**Re: Lot 2 Block 9 SAD 228
Volcano Cliffs Subdivision Unit 18
6605 Petirrojo Rd. NW
Grading and Drainage Plan
Engineers Stamp Date 11/2/2021 (D10D003I2)
Pad Certification Date 11/16/2021
CO Certification Date 12/13/2022**

Based on the Certification received 12/15/2022, the site cannot be accepted for release of Certificate of Occupancy by Hydrology until the following comments are addressed.

ENGINEER'S SEAL 3/1/21 DAVID SOULE P.E. #14522	LOT 02 BLK 09 UN 18 VC 6605 PETIRROJO ROAD NW	DRAWN BY DEM DATE 2-27-21 Lot 02 Blk 09 Un 18 VC.DWG
	GRADING AND DRAINAGE PLAN PO BOX 93924 ALBUQUERQUE, NM 87199 (505) 321-9098	SHEET # C1 JOB #

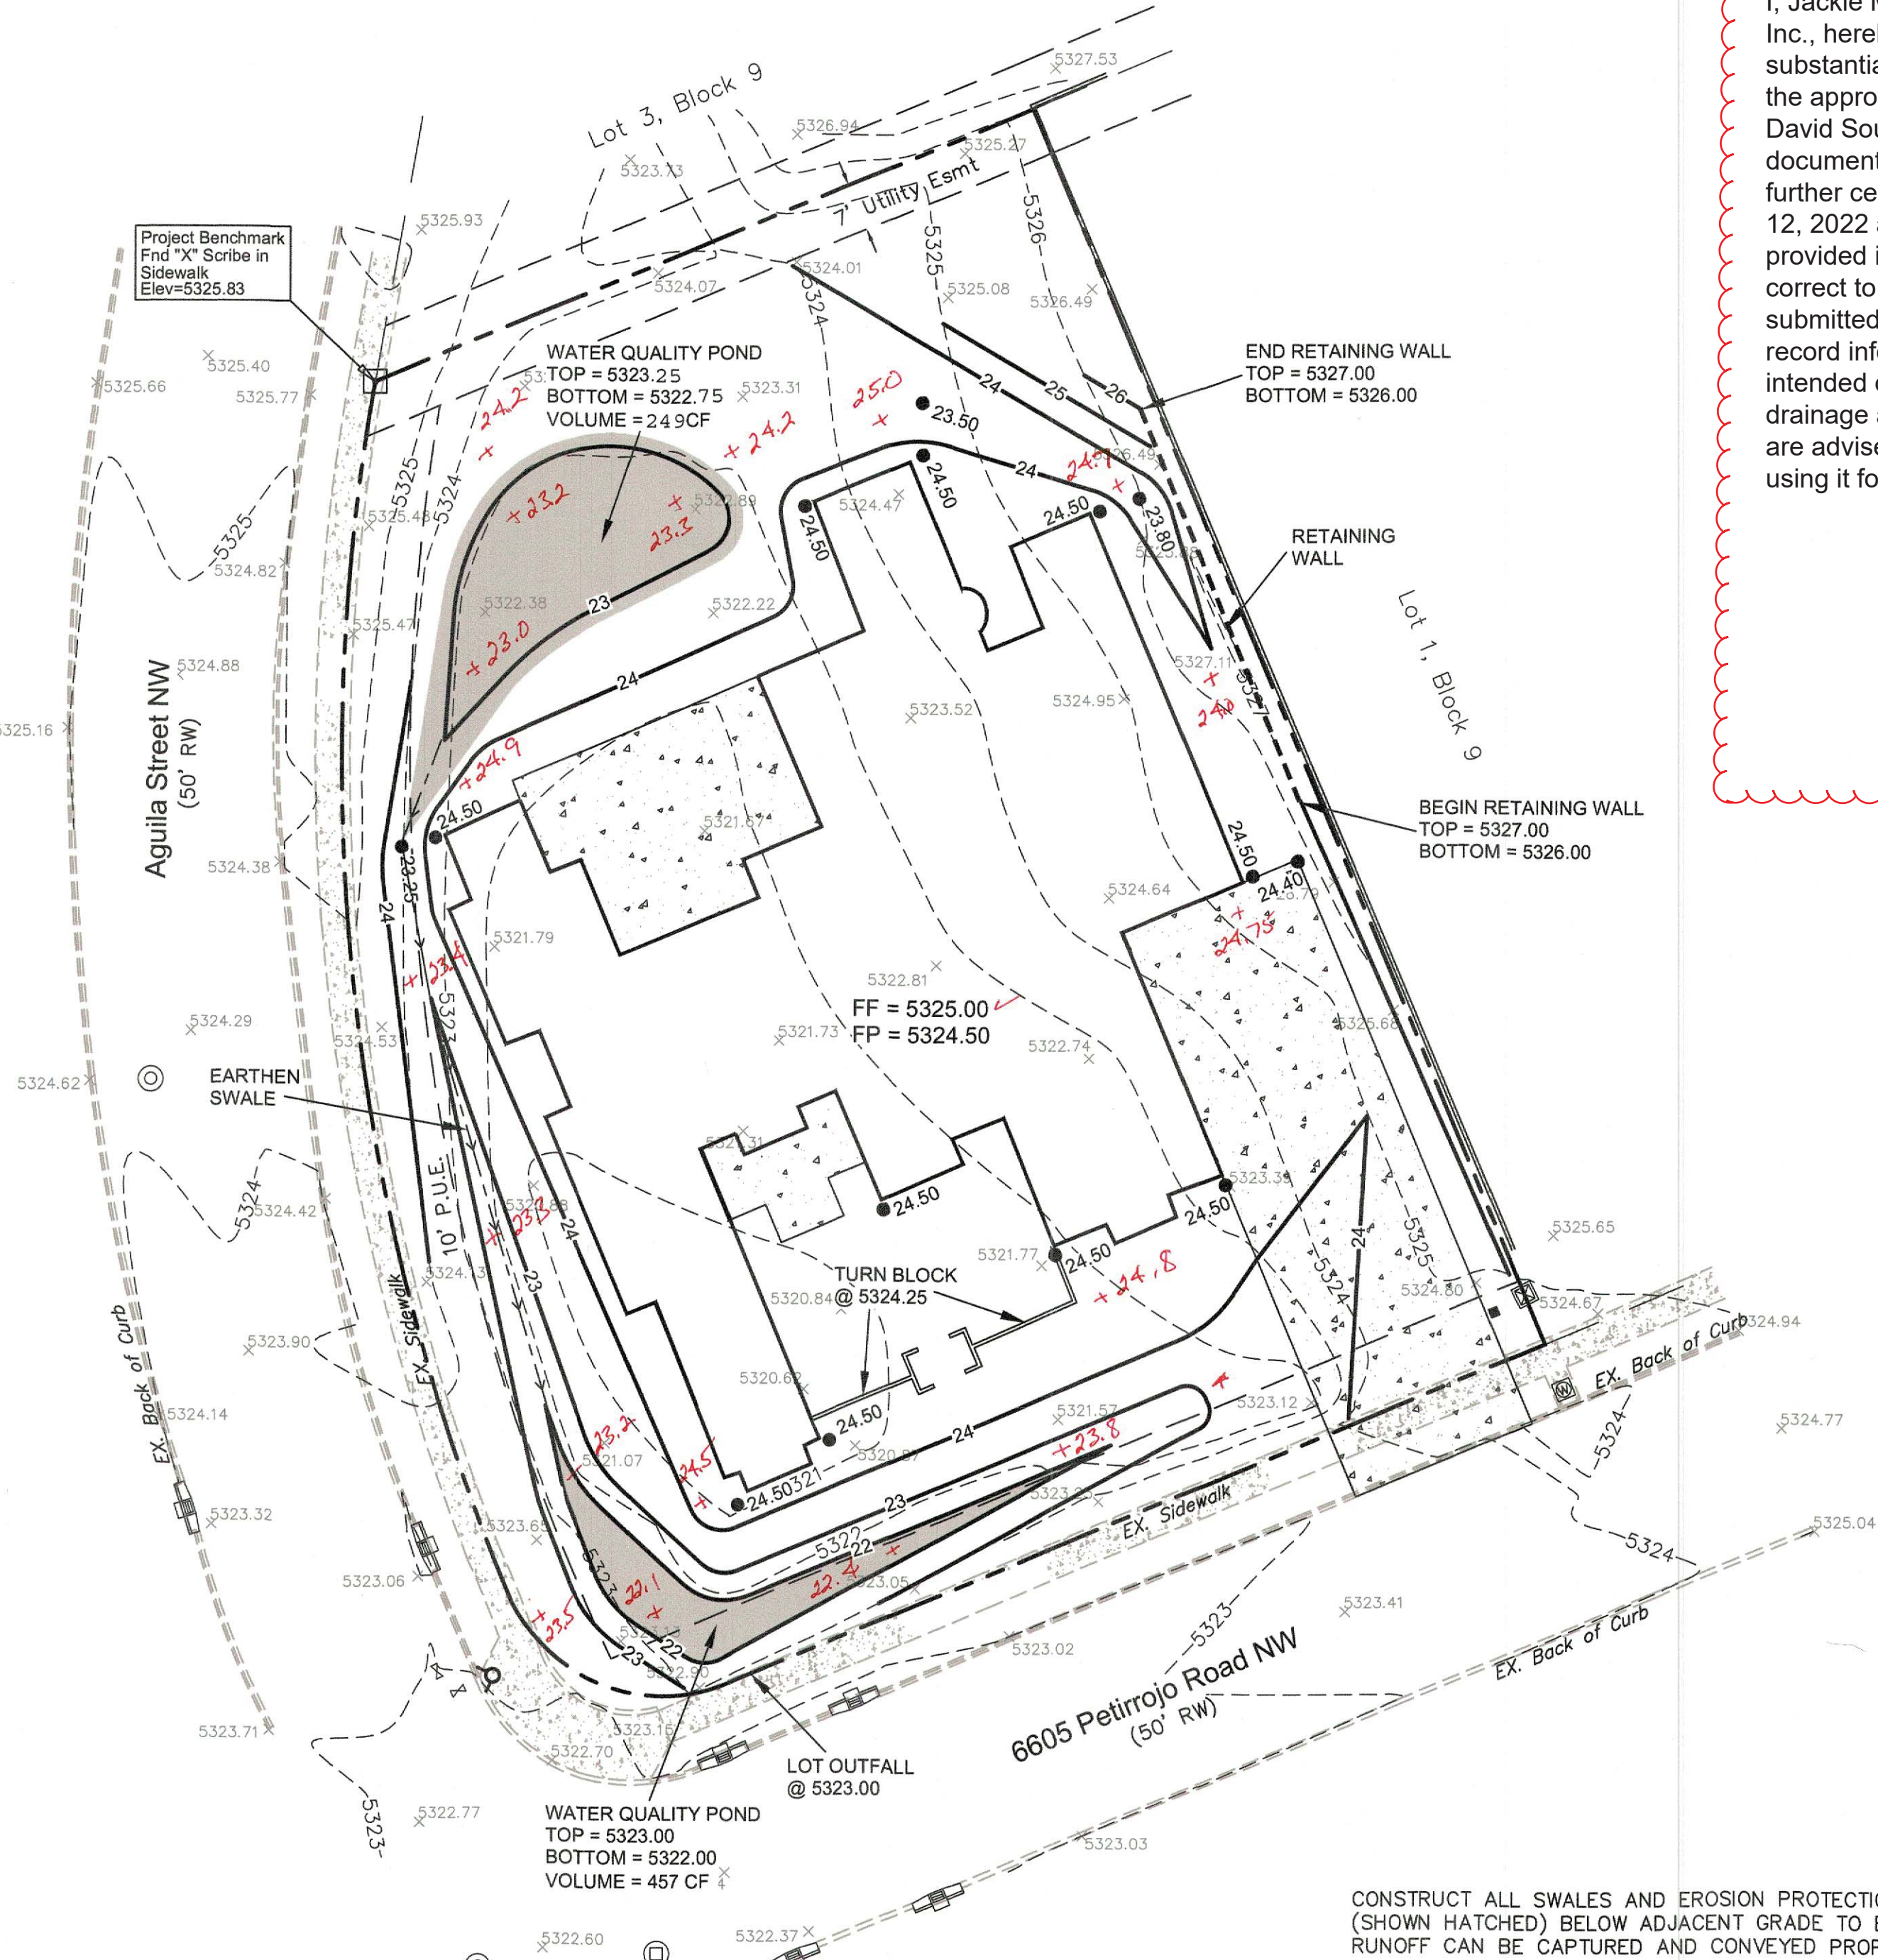
- Remove the port a potty.
- The back yard needs to have erosion protection.
- Replace the cracked side walk at the hand-I cap ramp.
- Replace the missing sidewalk in front of the drive pad,
